SERVICE BULLETIN NO: 27-003

MODIFICATION NO: EC 08-0510

FLIGHT CONTROLS - FLAPS REPLACEMENT OF THE LEAF SPRINGS IN THE FLAP OPERATING MECHANISM

Leaf Springs - Removal / Installation
Figure 1

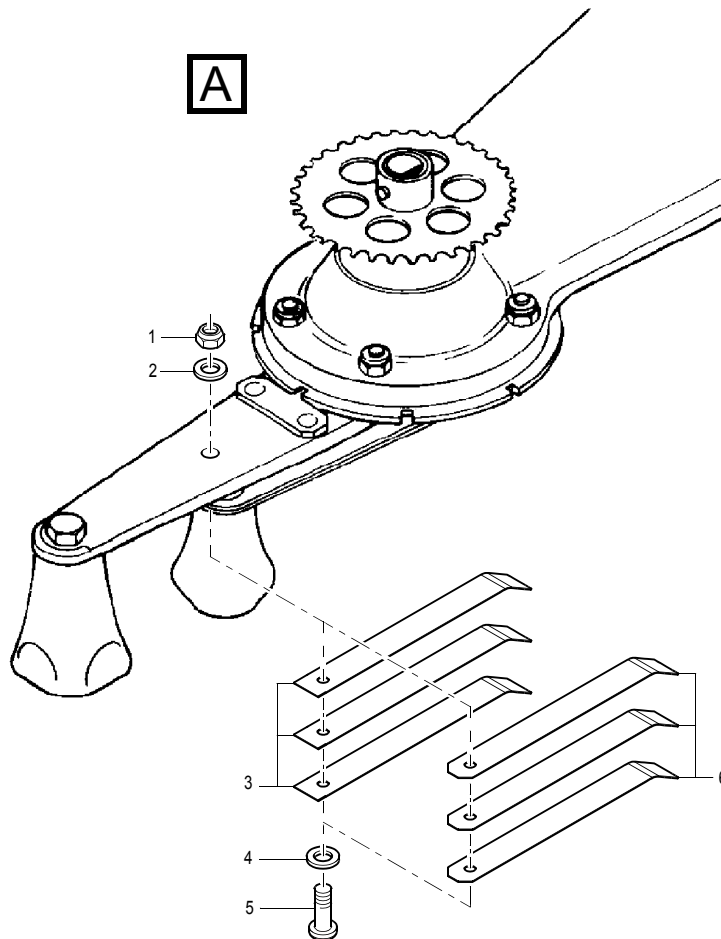
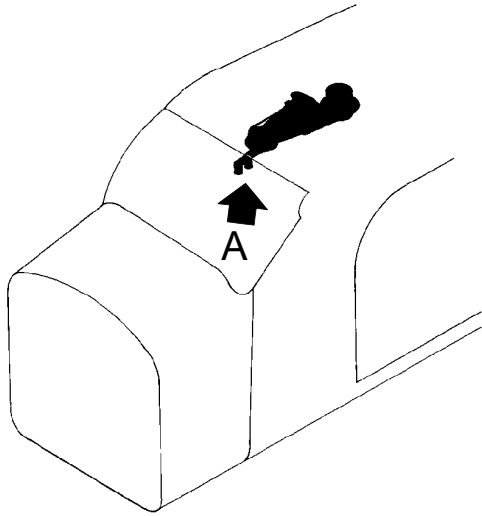
An Operator reported an un-commanded movement of the flap system. The un-commanded movement was because of cracked leaf springs P/N 6232.0175.01 installed in the overhead flap-operating mechanism of some PC-6 aircraft.

It is possible that the leaf springs P/N 6232.0175.01 were not manufactured correctly.

Replace the leaf springs (P/N 6232.0175.01) installed in the overhead flap-operating mechanism for this newly manufactured leaf spring (P/N 116.45.06.040).

- (1) Remove the nut (1), the washers (2) and (4) and the screw (5).
- (2) Remove the three leaf springs (3).
- (3) Put the new leaf springs (6) (P/N 116.45.06.040) in position.

NOTE: The new leaf springs (6) (P/N 116.45.06.040) have 45 degree chamfers adjacent to the attachment hole.

- (4) Install the screw (5), the washers (4) and (2) and the nut (1).
